Proposed Amendments to the Drawings

**REMARKS****Objections to the Drawings**

FIG. 4B

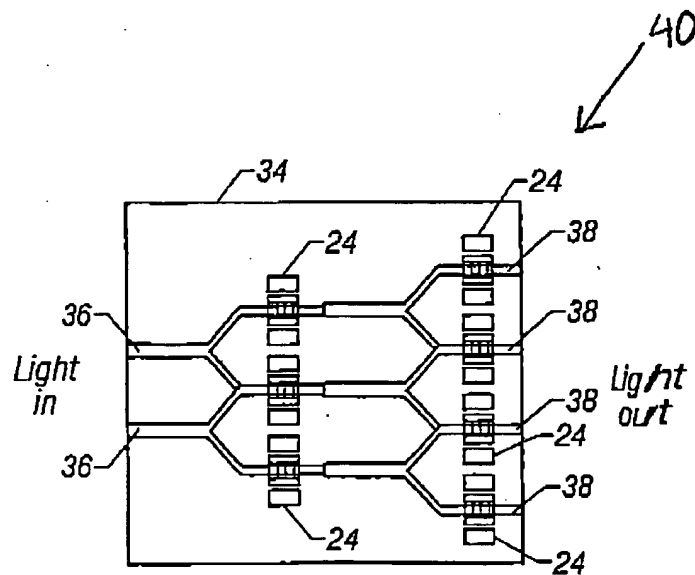
The drawing are objected to as failing to comply with 37 CFR 1.84(p)(4) because reference number "54" has been used to designate both the top electrode and the bottom electrode, and in Figure 4B, "40" is missing.

The drawings are objected to as failing to comply with 37 CFR 1.84(p)(4) because reference number "54" has been used to designate both the top electrode and the bottom electrode, and in Figure 4B, "40" is missing.

Figure 4(b) has been amended to include reference number 40. Figure 7 has been amended to add reference number 56.

Applicant submits proposed amendments to Figure 4(b) to include reference number 40 and Figure 7 to add reference number 56.
